**Application for Planning Permission Under Section 16 of the Town Planning Ordinance (Cap. 131) for Proposed Hotel Use and Minor Relaxation of Plot Ratio Restriction at "Other Specified Uses" Annotated "Business (1)" Zone at No. 646-648A Castle Peak Road, Cheung Sha Wan, Kowloon
(Planning Application No. A/K5/879)**

Submission of Further Information – Responses to Departmental Comments

Responses-to-Comments Table

Drawing Title
GROUND FLOOR PLAN

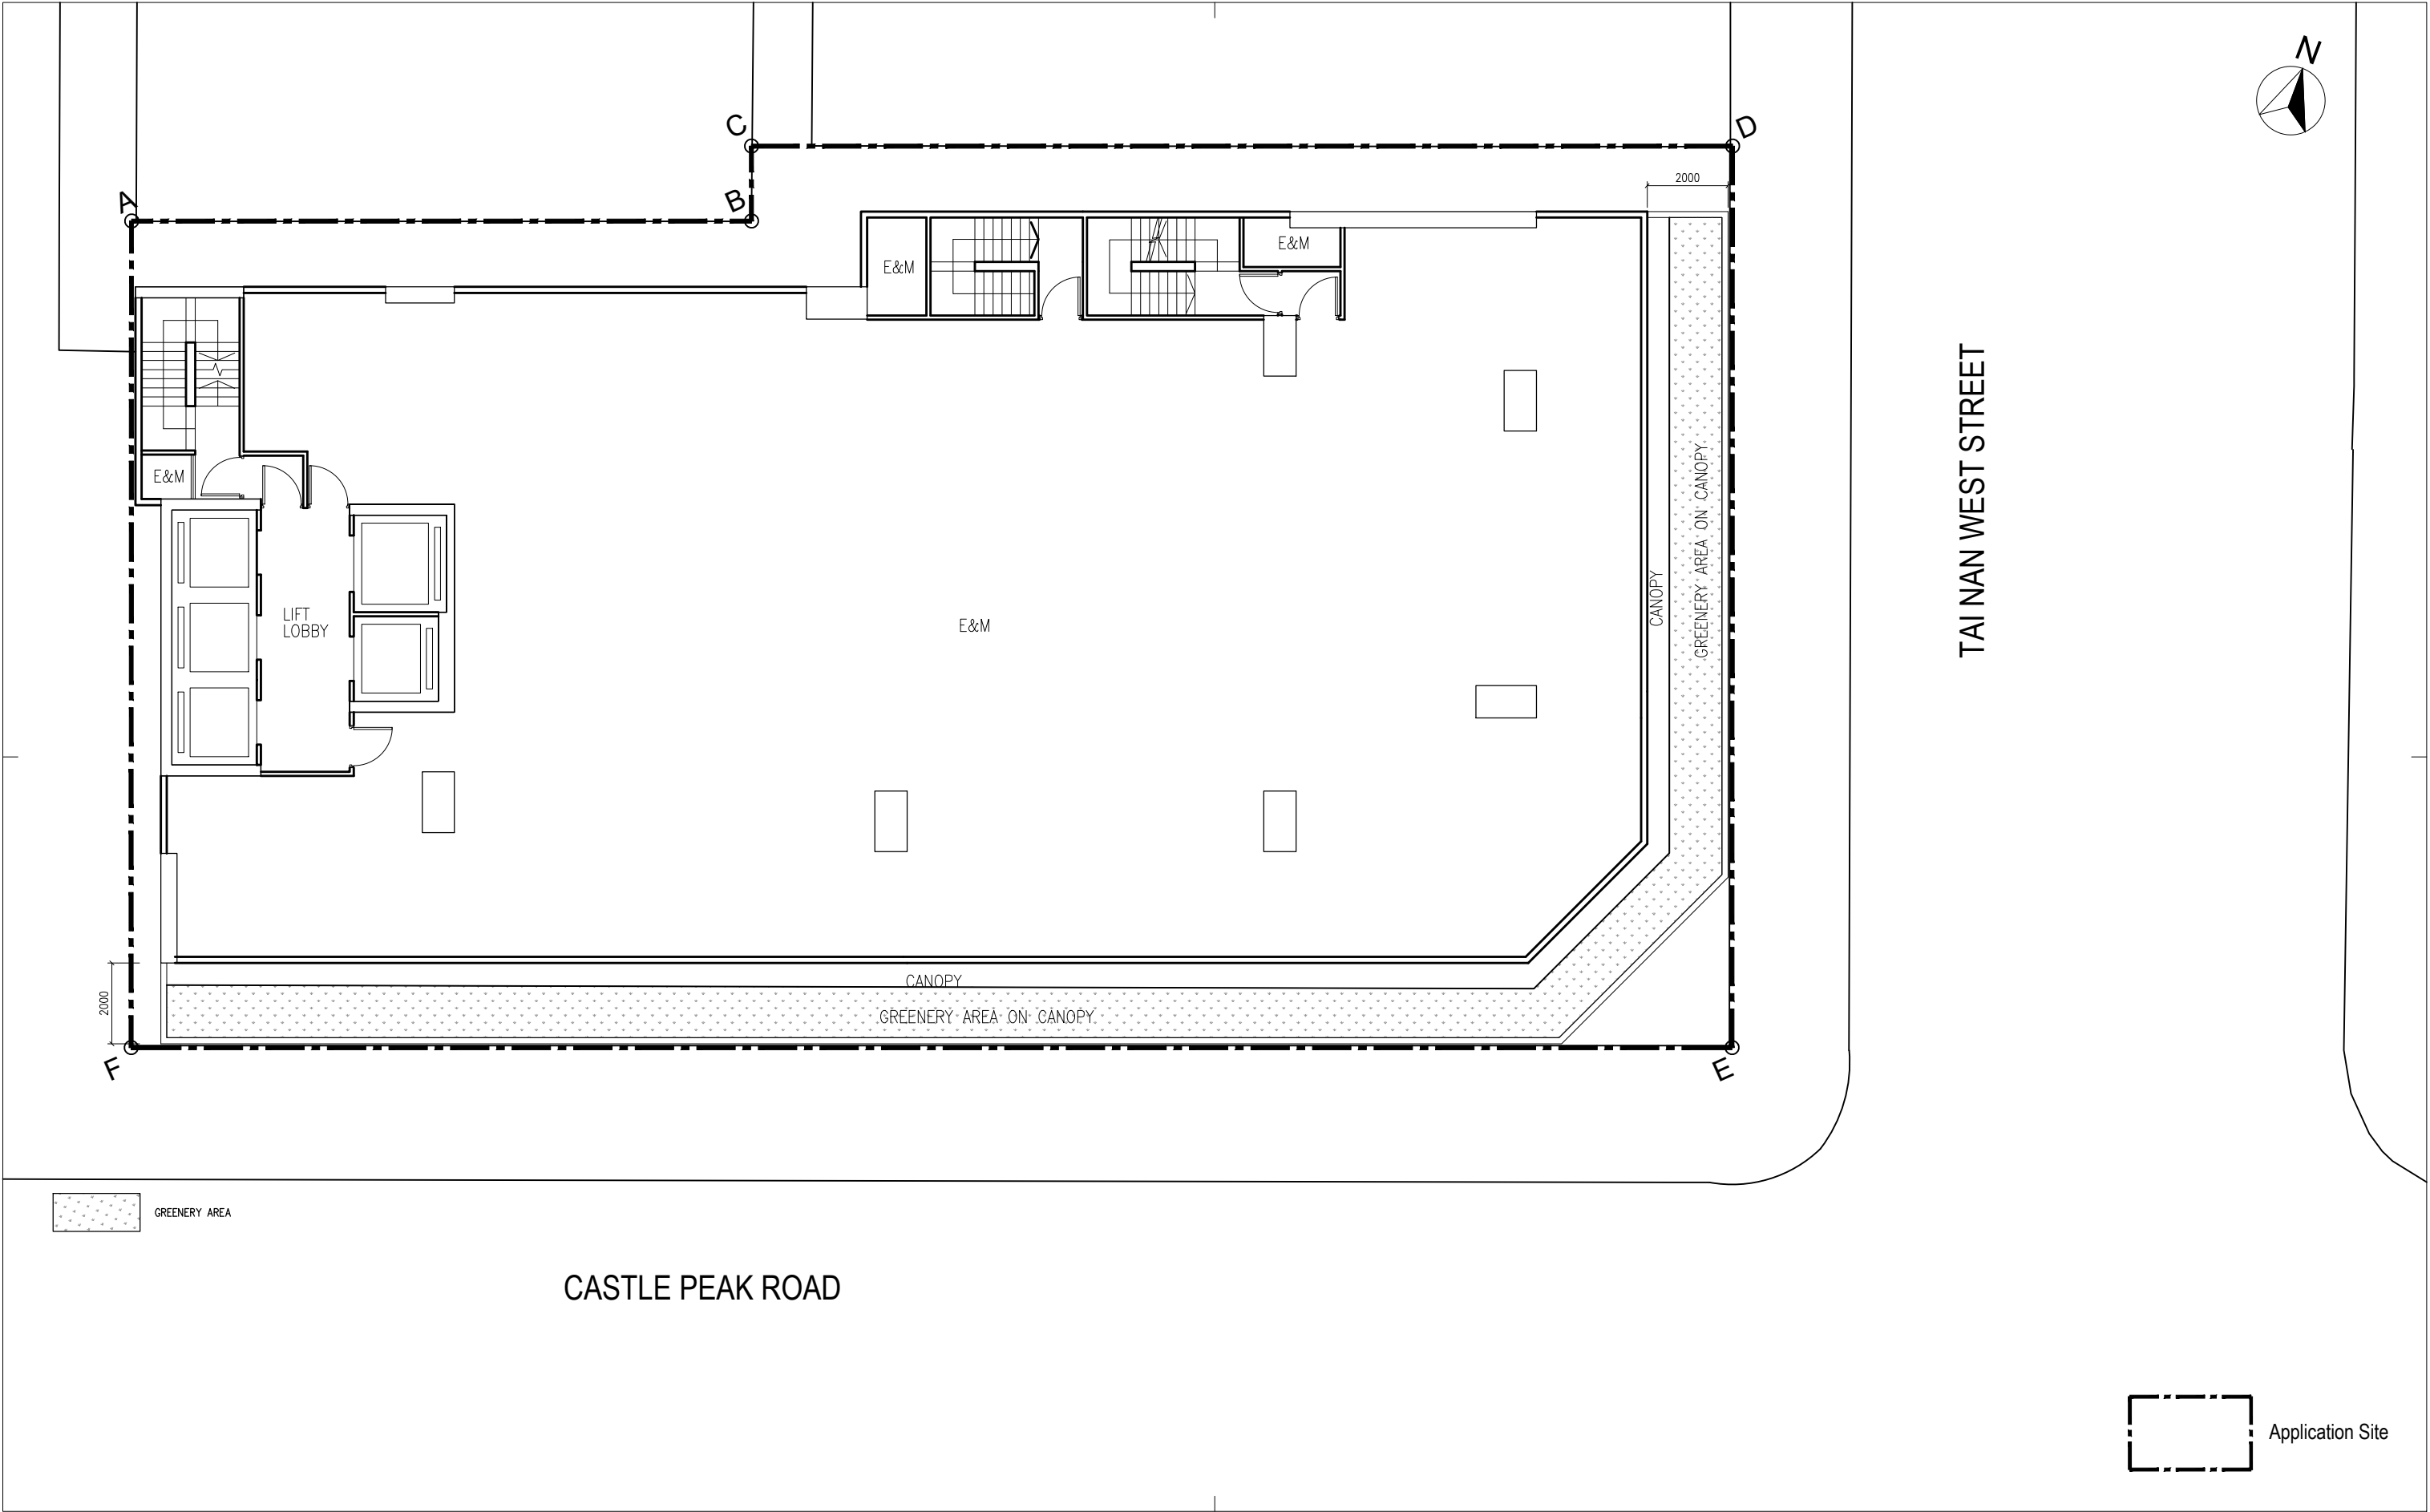
7. Ground Floor Plan – the current design of the greenery area may occupy part of the pedestrian circulation area. Reference can be made to the scheme for the previous s.16 application no. A/K5/838 especially on the location of the greenery area and walkable tree grille to revise the proposed greenery measures.	To enhance the pedestrian circulation and comfort, the ground floor greenery proposal has been refined, taking into account the comments received from relevant Government departments. Please refer to the revised Architectural Layout (Annex D refers)

Drawing Title
1ST FLOOR PLAN

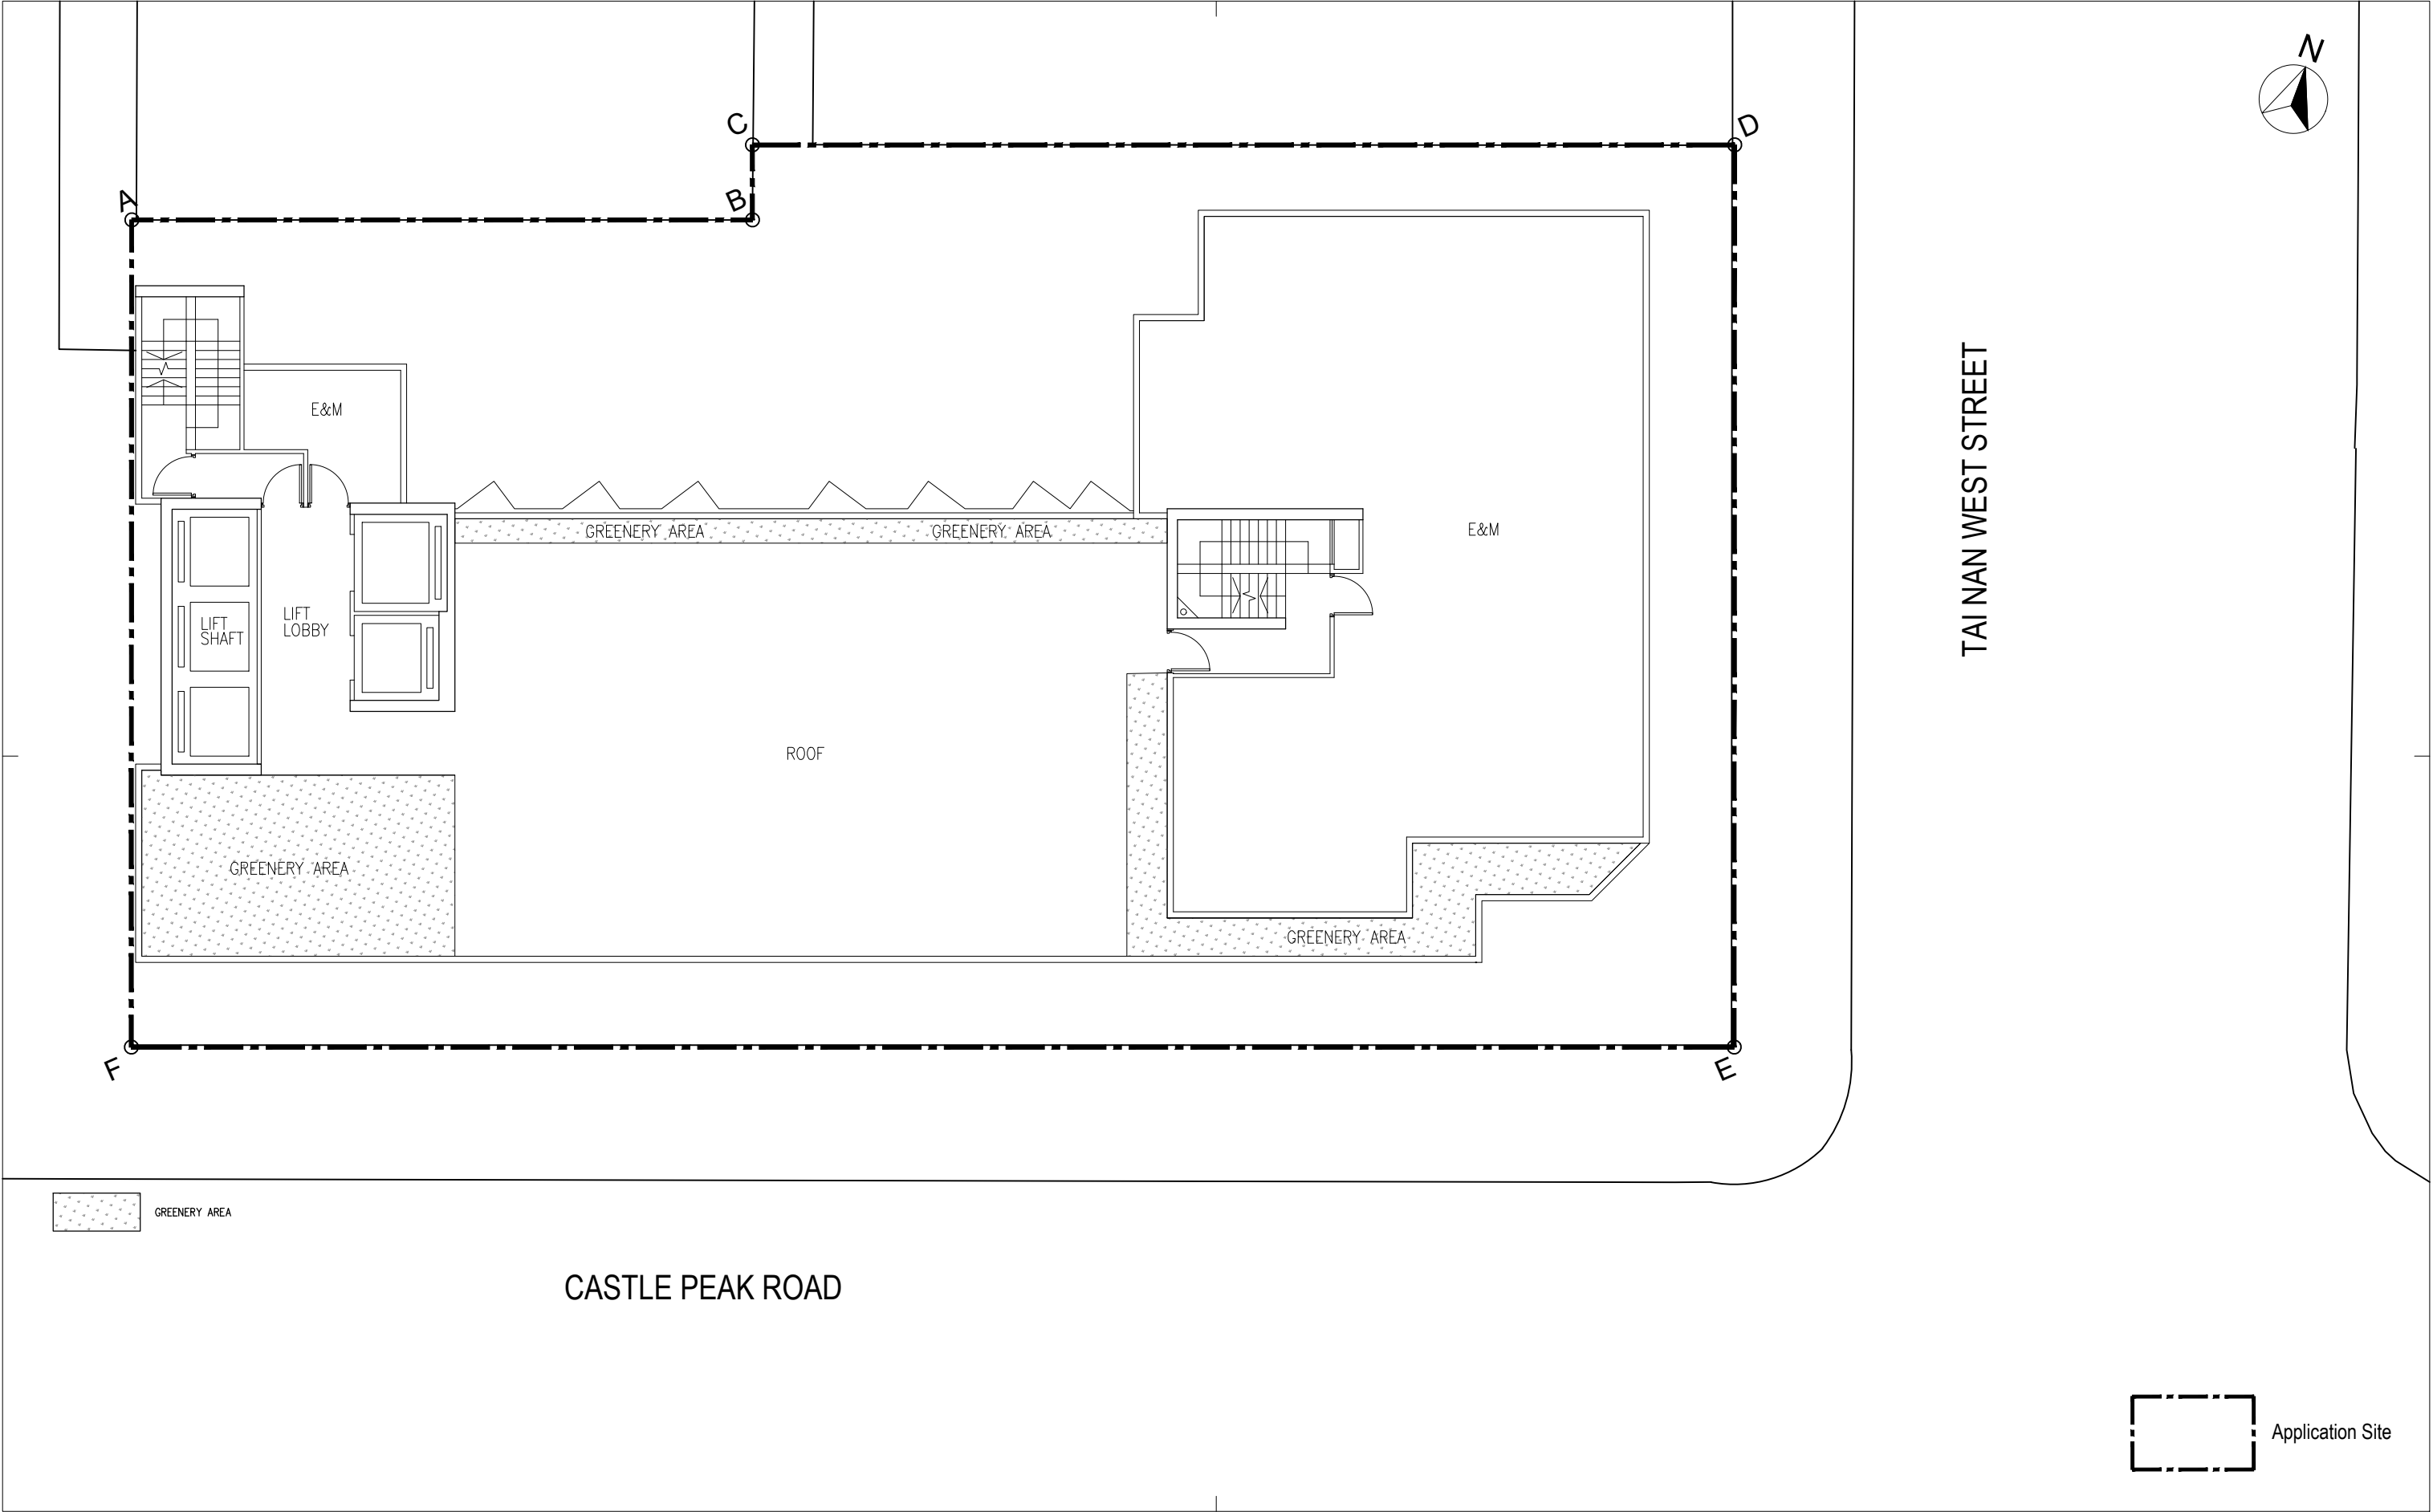
8. 1st Floor Plan – Please advise if the Greenery Area is part of the canopy. If affirmative, please revise the annotations in the plan for the sake of clarity.	Please note that the Greenery Area is part of the canopy. The annotation is revised to “greenery on the canopy”. Please refer to the revised Architectural Layout (Annex D refers)	
	Appendix B
